City of NAPOLEON, OHIO

September 16, 1988

Re: Sun Discount Drug, 135 E.
Maumee, Napoleon, Ohio. Drive
Approach & Sidewalk Area.

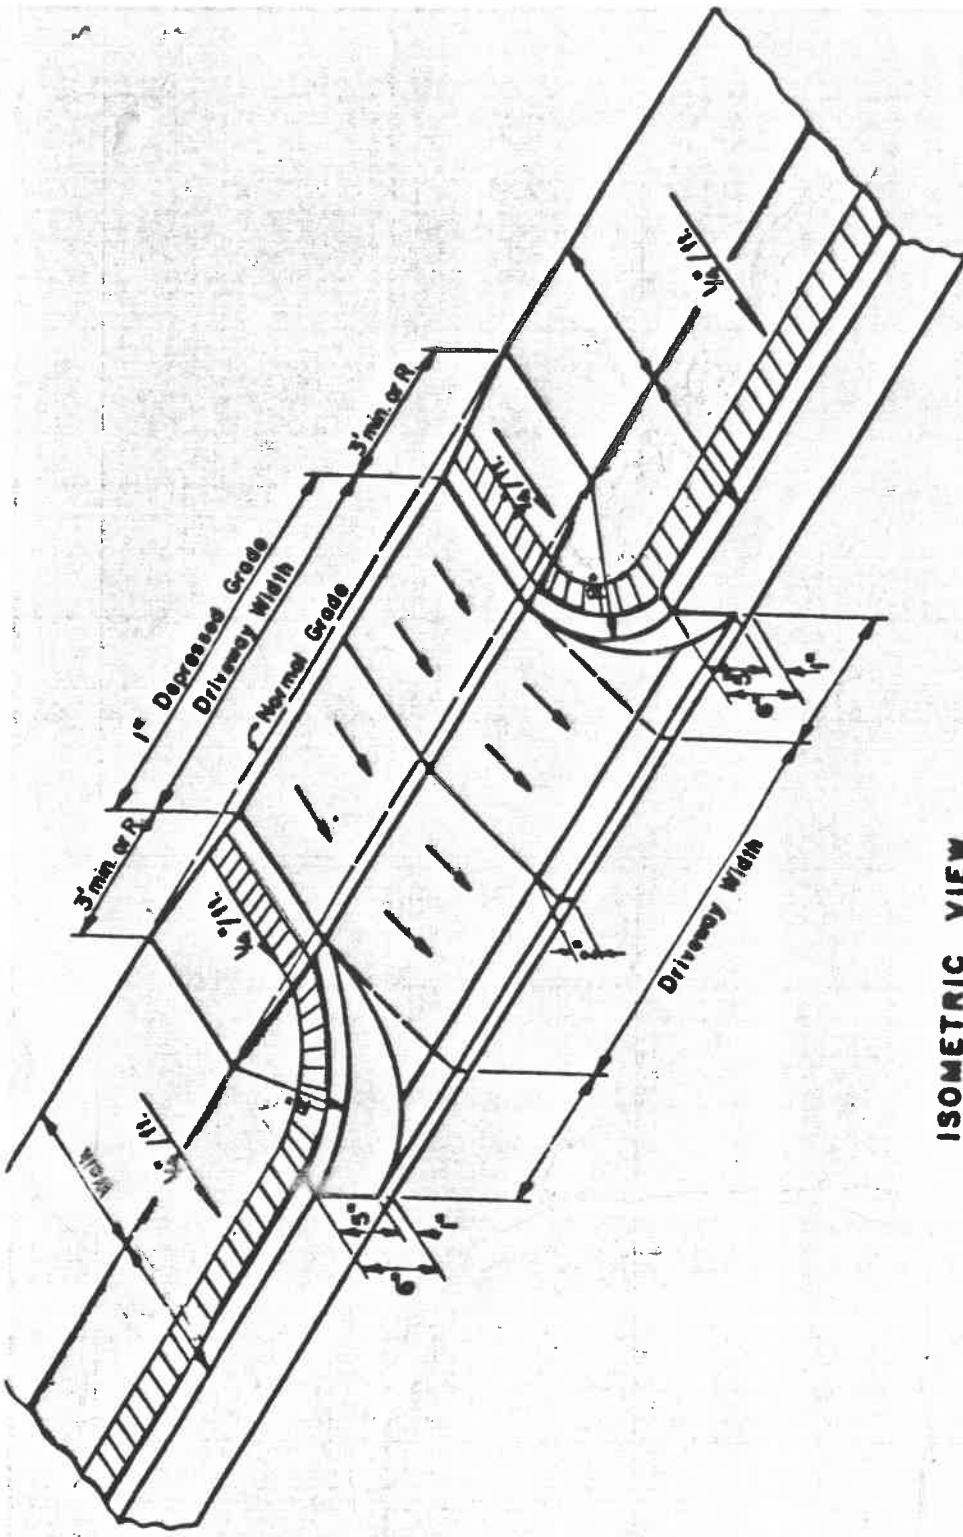
Please ignore the brick pattern shown on these drawings. The asphalt will be flush with the edge of the sidewalk. The back edge of the sidewalk will be at the right-of-way line. There will be a 6" type 6 concrete curb with all construction meeting the City of Napoleon and 1987 O.D.O.T. Specifications. You are required to pick up a curb and sidewalk permit from the City Engineering Office. There is no fee involved, but is a signature to allow you to work within the Right-of-way.

After reviewing your request for placing asphalt up to the concrete curbing, it has been decided that concrete should be used to take care of the tree lawn problem rather than asphalt. I have enclosed a standard drawing of the same type of concrete drive approach that will be used by Petro Pantry at their new location, 501 Perry Street. This is the Standard for all new construction.
